Summary	Retrofit to Light Curtains from Photo Eyes on Spiral Doors				
Products Affected	Spiral Doors with Photo Eyes				
Key Word Tags	SD, Light Curtain, Retro				
Tools/Equipment (If Required)					
Parts/Materials (If Required)	R00122022 (1ea) LIGHT CURTAIN TRANS, TST LGBS-C,2087MM R00122023 (1ea) LIGHT CURTAIN RCVR, TST LGBE-C,2087MM R00141086 (1ea) CABLE,ENCODER,M12,FEMALE,TYPE A,8PIN,15M R0012154 (1ea) CABLE 4PIN STRAIGHT PE 15M 50' R1071627-0 (10ea) CLIP, LIGHT CURTAIN, FEIG R00112119 (1ea) LIGHT CURTAIN INTERFACE BOARD,SYS4				
Related Media	System 4 Drive and Control Manual, USB Stick with 1.50 software, Bulletin 249				
Author	Mike Burzlaff	Issue Date	04/11/19	Status	Active

Please Read The Entire Bulletin Before Proceeding

The spiral door can now be retrofit from the photo eyes on either side of the door opening to the light curtains which will be in the door path.

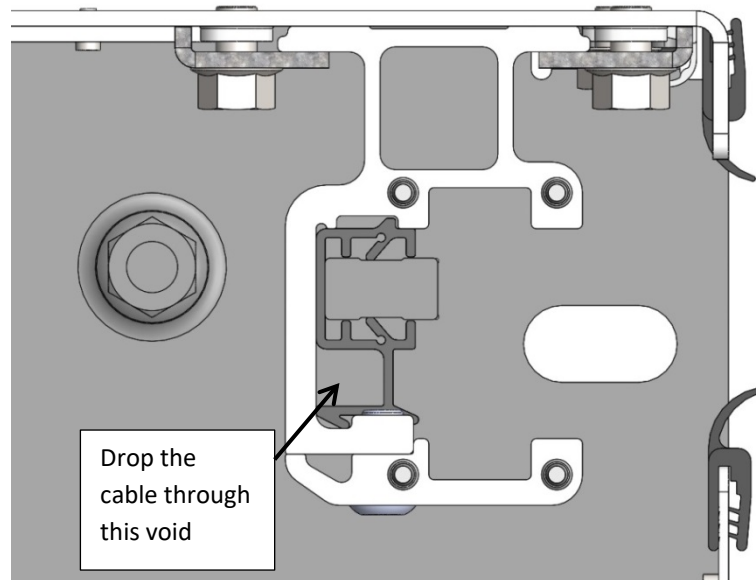
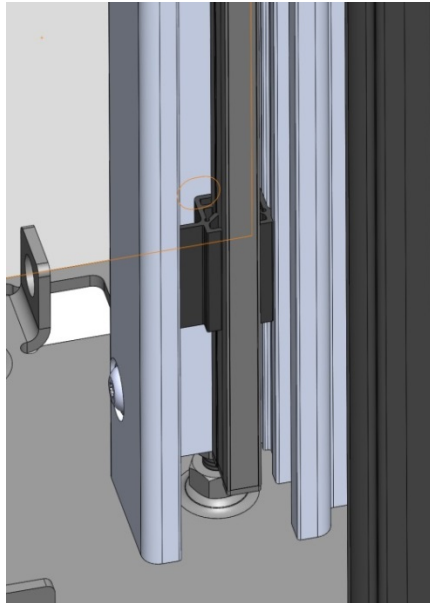
Install the clips provided into the column. Space them out equally for the length of the light curtain.

Install the light curtain into the clips. The cords should be on the top of the guides. The light curtains should be flush to the bottom of the guides, which should be approximately 2" from the baseplate of the column. **Make sure the protective film has been removed from the light curtains.**

Feed the cable through the clips from the top down with the quick connect at the top by the light curtain. The cable needs to be pulled tight all the way through the clips to prevent being damaged by the rollers during door travel. **(See note above)**

DOOR HEAD J-BOX
RYTEC BUILT SPIRALS W/
LGBX LIGHT CURTAINS

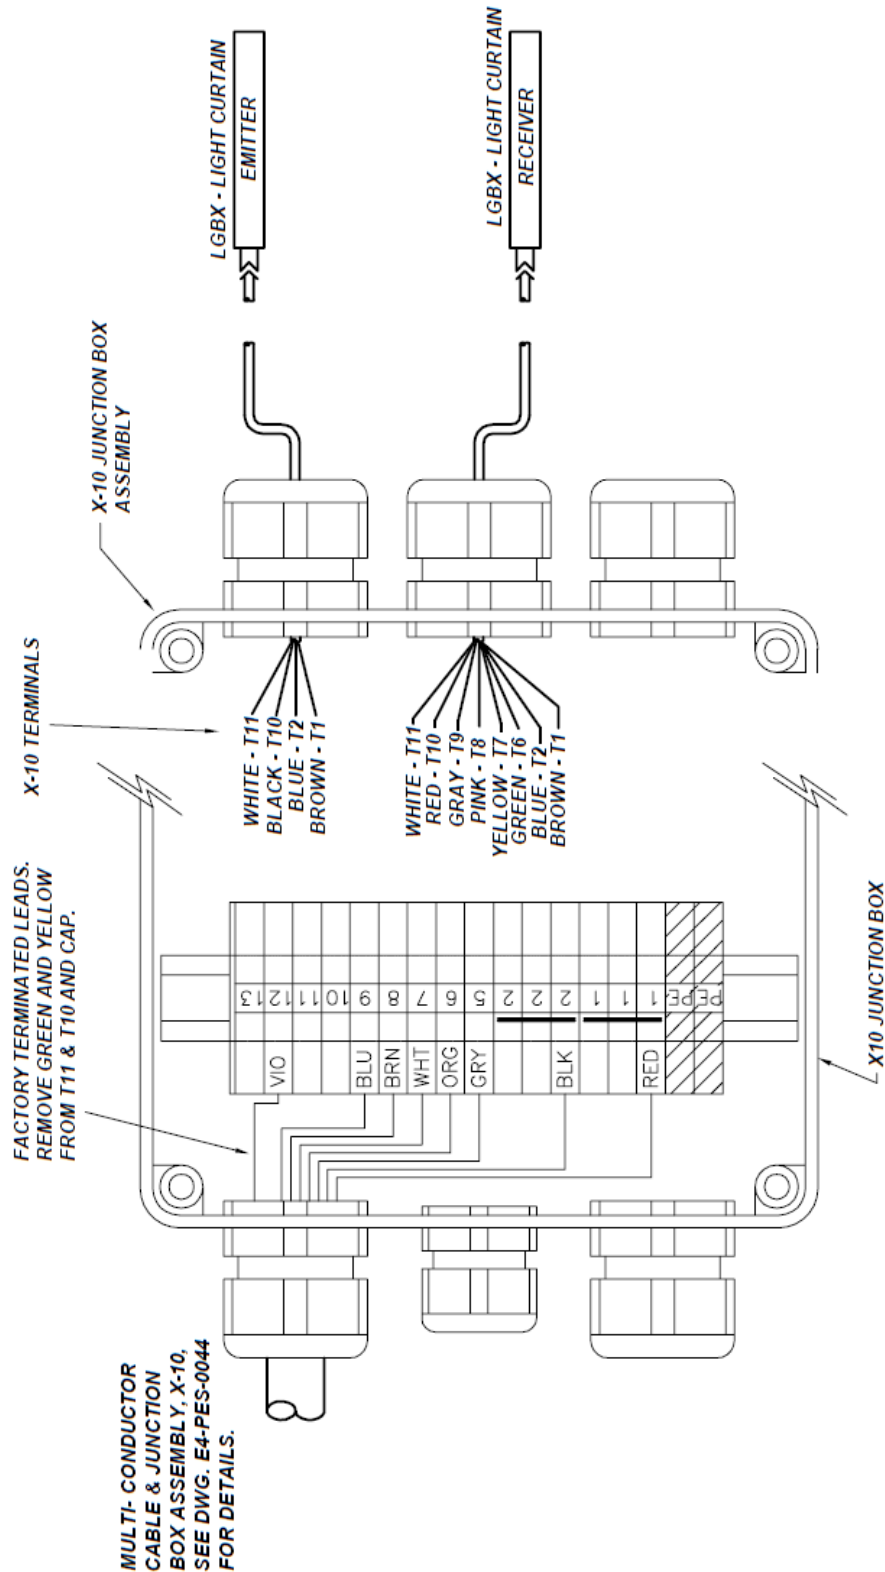
Route the cables from the bottom of the guide through the column conduit to the x10 junction box in the head assembly (this should be the same path the old photo eye cables took). Make the terminal connections as per the schematic below. **(x10 J-box Connections pg. 4)**

X10 J-box Connections

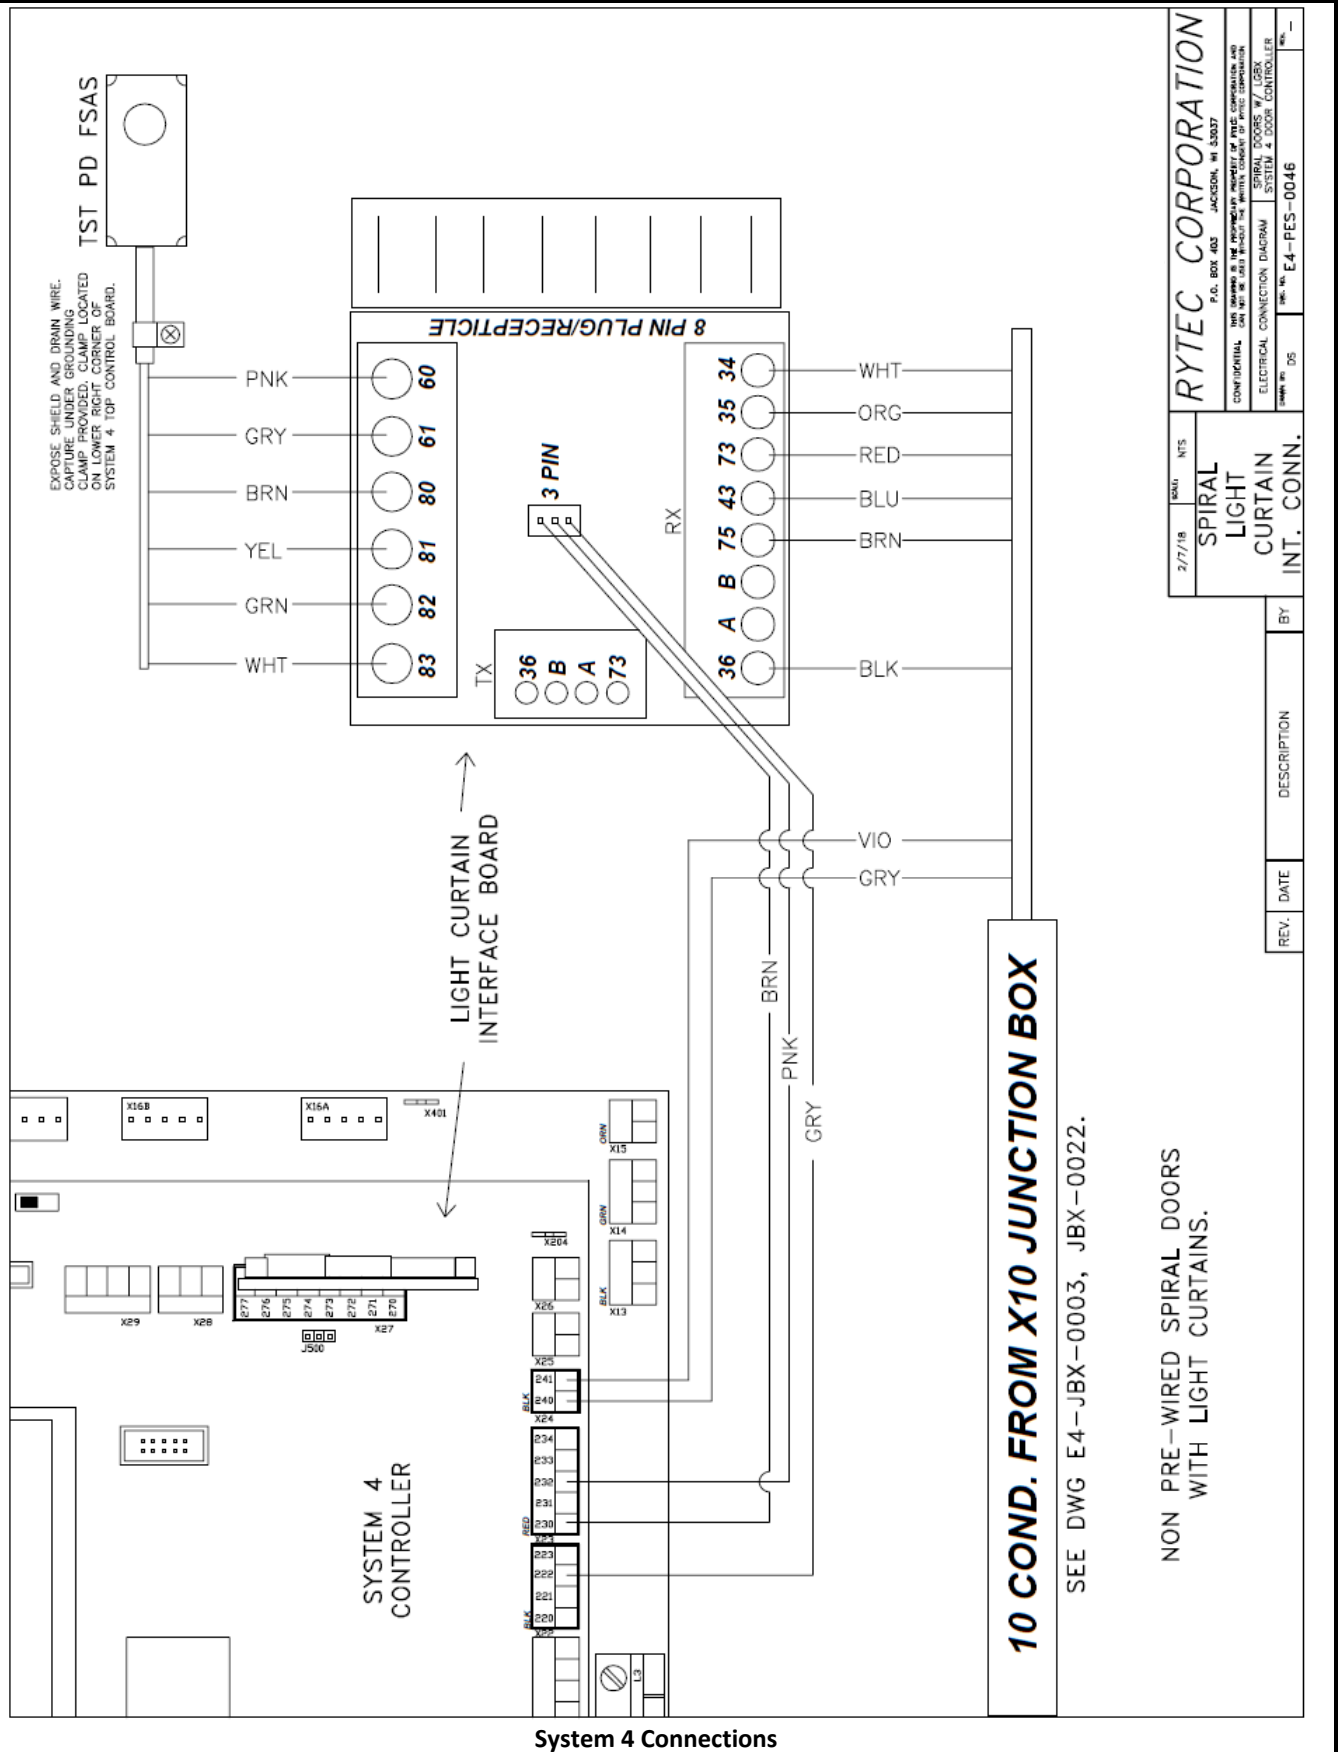
Install the light curtain interface board on the old encoder terminal block position. Connect the wires from the x10 cable and the encoder cable per the schematics below. **(System 4 Connections pg. 5)**
